METROPOLITAN GOVERNMENT OF NASHVILLE AND DAVIDSON COUNTY

STAFF RECOMMENDATION 2005 20th Avenue South September 19, 2012

Application: New construction—addition; Partial demolition
District: Belmont-Hillsboro Neighborhood Conservation Zoning Overlay
Council District: 18
Map and Parcel Number: 10412011100
Applicant: Van Pond, AIA
Project Lead: Melissa Baldock, melissa.baldock@nashville.gov

Right façade, as seen from the front.

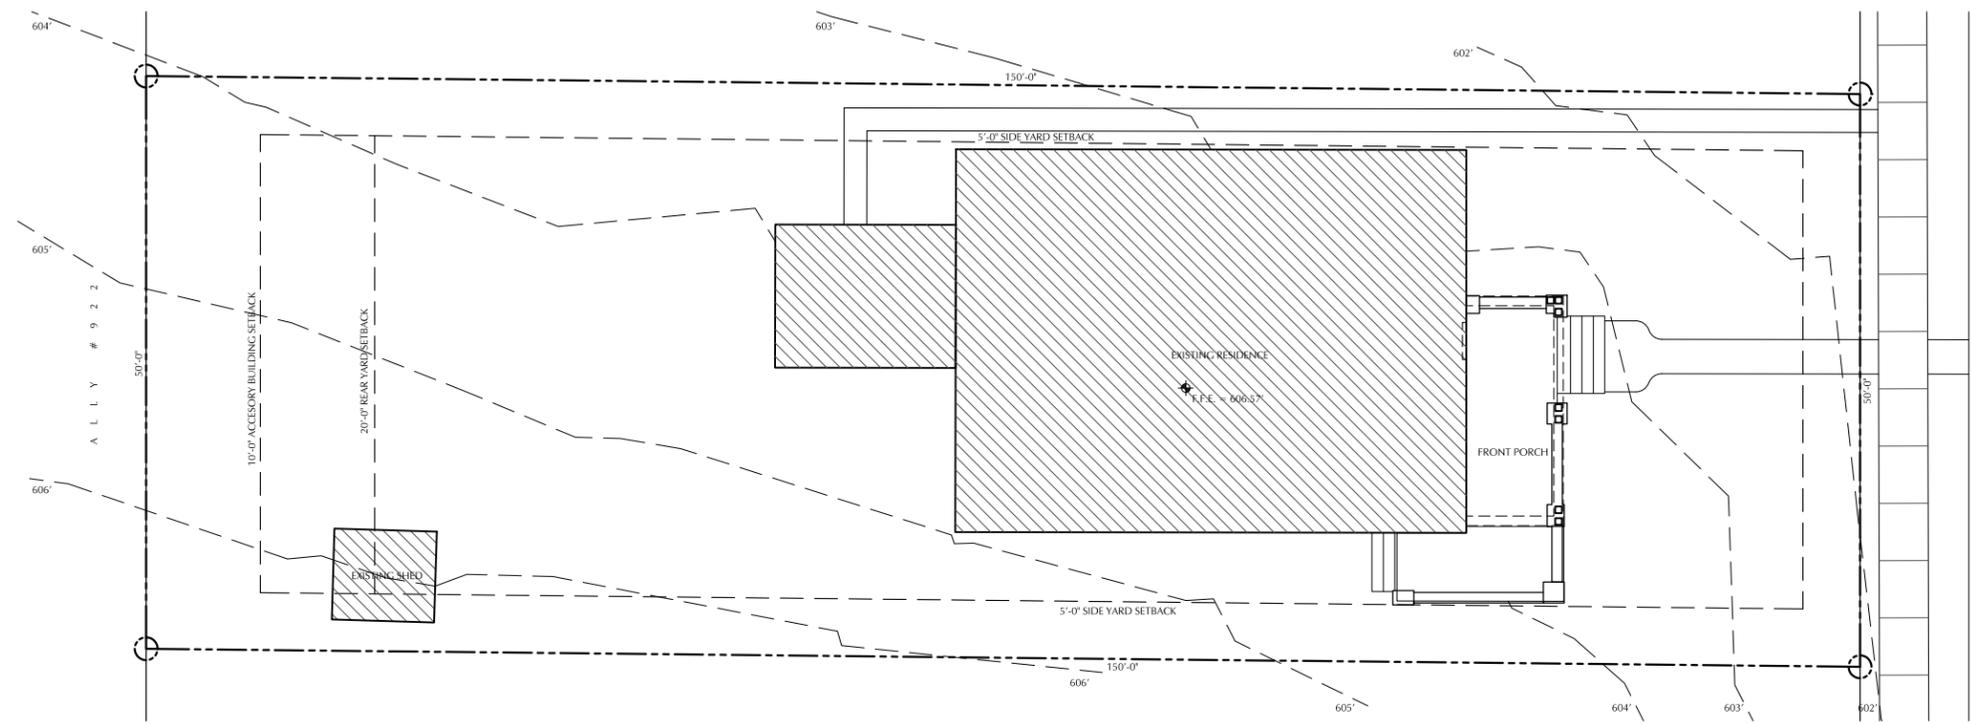
Utilities. The site plan indicates that the house's new HVAC units will be located on the left façade, approximately at the house's halfway point. They will be partially hidden by the front porch, which extends beyond the sidewall of the house. The new units will be in the same general location as the existing HVAC unit (see photo below). Staff finds the proposed HVAC location to meet Section II.B.1.h. and II.B.2.a. of the *Belmont-Hillsboro Neighborhood Conservation Zoning Overlay: Handbook and Design Guidelines*.

Proposed Site Plan

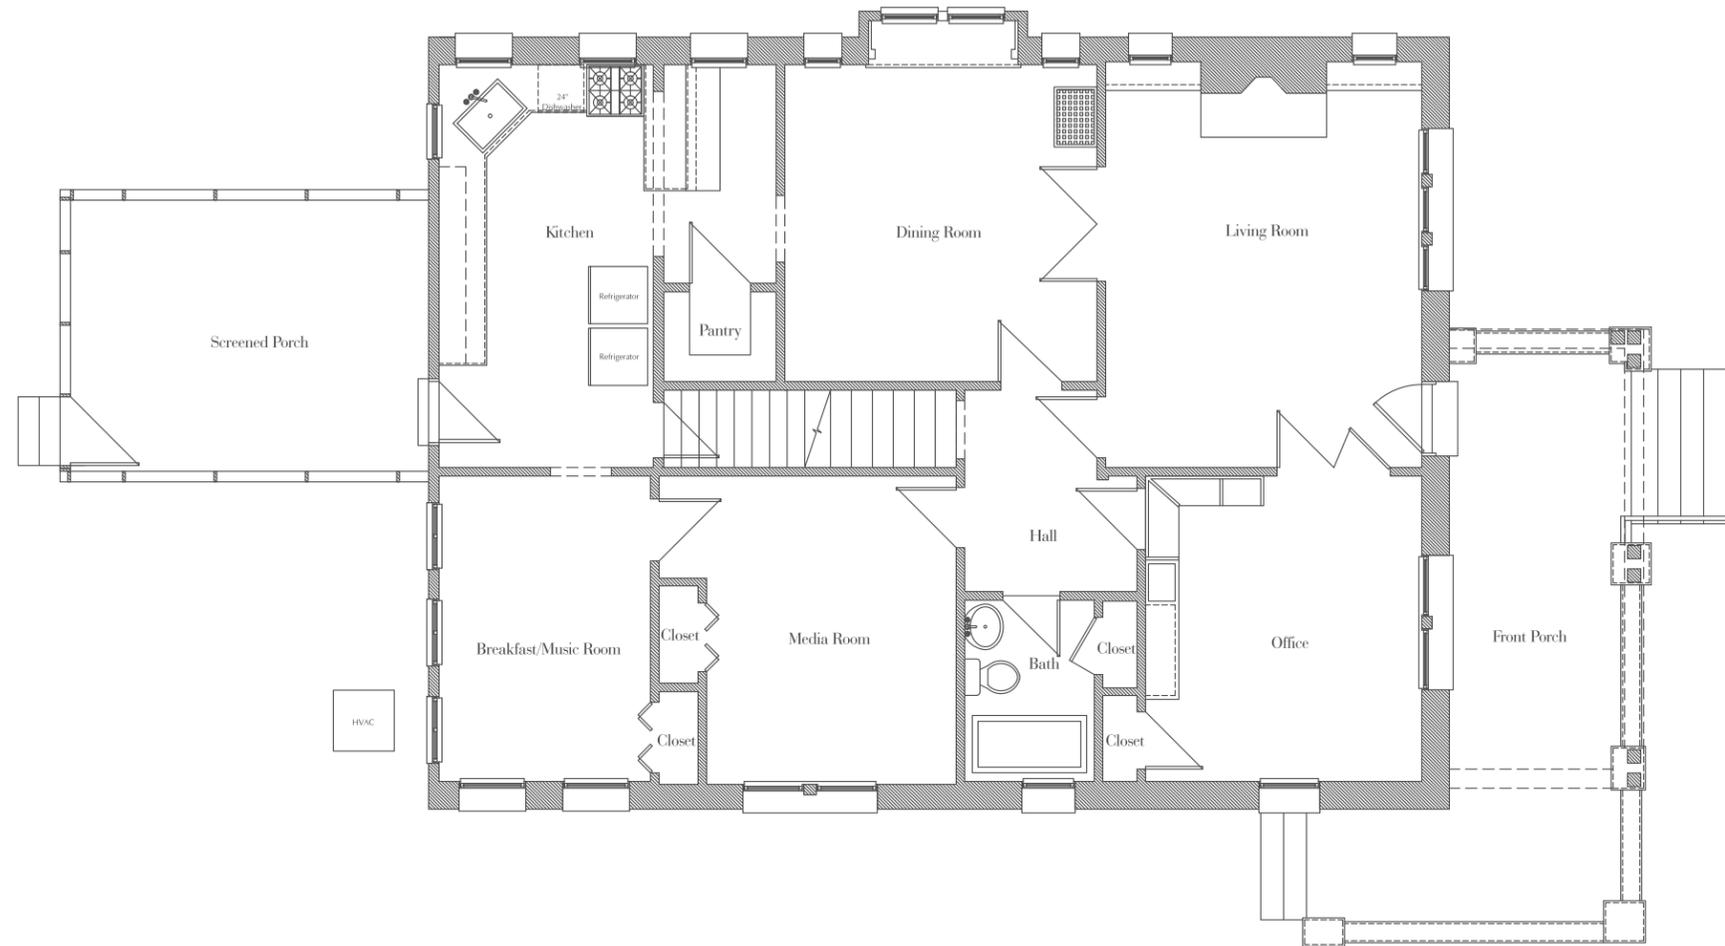
Location and Setback: The proposed addition is located entirely behind the historic house. It is inset from the sidewalls of the historic house two feet, six inches (2'6") on the right side and approximately fourteen feet, six inches (14'6") on the left side. The addition meets all base zoning requirements for setbacks. Staff finds the location and setbacks of the proposed addition to meet Sections II.B.1.c. and II.B.2.a. of the *Belmont-Hillsboro Neighborhood Conservation Zoning Overlay: Handbook and Design Guidelines*.
